**MUNICIPAL SERVICES CENTER, COUNCIL CHAMBER
3600 TREMONT ROAD**

Subject: 2286 Yorkshire Road (VAR-52-23) - To allow an addition to encroach up to 3'-11" into the 10-foot minimum south side yard setback, up to 6'-3" into the 12'-4" side yard longwall setback, and results in a side yard sum of 12'-5" (13'-5" existing), when 20 feet is the minimum.

ZAFIRIDES RESIDENCE - UPDATED DESIGN + UA BZAP VARIANCES - 12.29.23

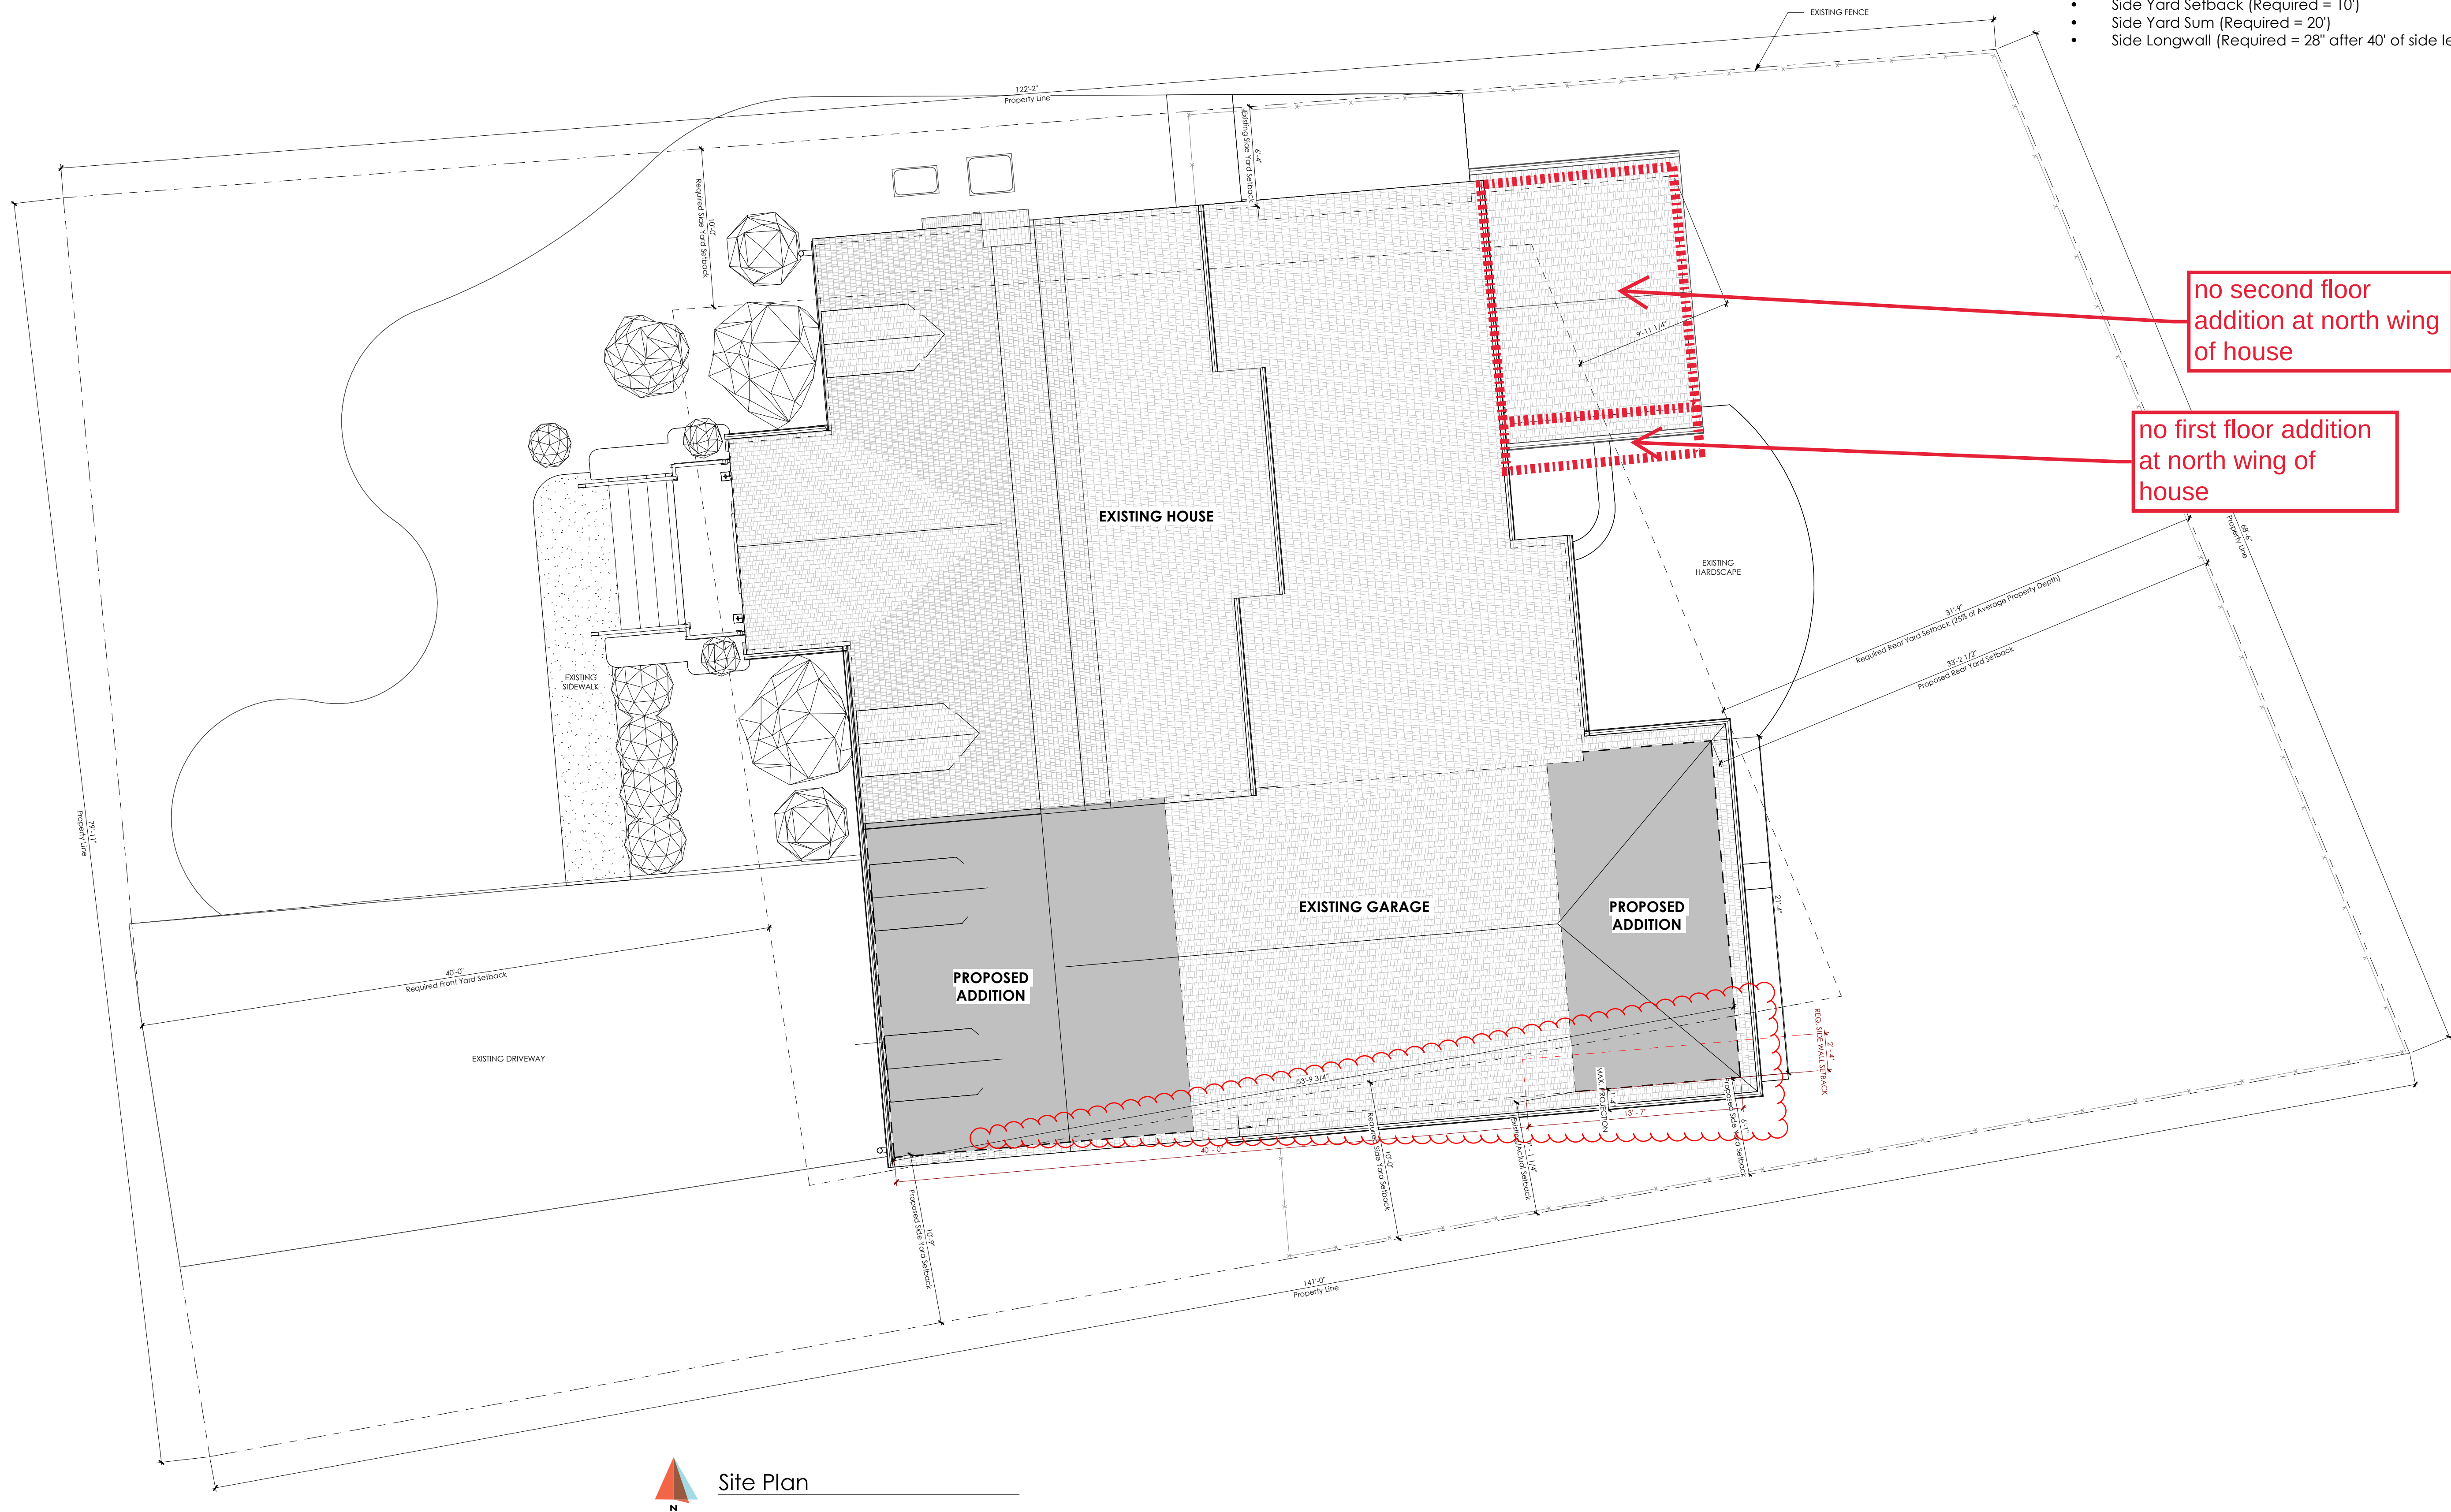
CODE ITEM	EXISTING CONDITIONS	NEW VARIANCE REQUESTED	COMMENTS
Side Longwall : 28" Stepback required at new south wall	Existing north wall of house encroaches on stepback; 29" would be required	New south wall does not step back (encroaches 28")	We reviewed possible design revisions to accommodate these code items. However, the existing house already encroaches onto both of the existing Side Yard setbacks and does not meet the Side Longwall requirement. The shape of the property, with converging side yard boundaries that are not parallel to the existing house, make it difficult to build a coherently-designed home that makes the best use of the existing structure while adding the additional space that the clients desire. Specifically, the clients need a third parking spot in their garage. This is a reasonable request for a home in this neighborhood, and as architects, we always want to meet our clients' needs. However, with the original house's footprint and the location of the existing garage and drive, the southern two-story addition is not able to accommodate the side longwall stepback while still maintaining a third parking space. We extensively explored design revisions but they do not meet the project's needs.

Side Yard : 10'-0"	Encroaches 3'-8" at existing north wall, 2 stories	Encroach up to 3'-11" at new south wall, 2 stories	
Side Yard Sum: 20' minimum	13'-5" (insufficient)	12'-5" (additional 1' encroachment; insufficient)	
Rear Yard : 31'-9"	Encroach 9'-11 1/4" at existing addition; 1 story	None	Removed addition at Family Room from previous design
Rear Yard Profile Coefficient	None	None	Removed northern second floor addition from previous design
Article 7.17: Neighborhood Compatibility / Article 7.18 : Historic Building	The existing house has been modified multiple times and has lost many historically relevant details in the process. It is not historically significant to the neighborhood.	None	The proposed design does not require a neighborhood compatibility variance.
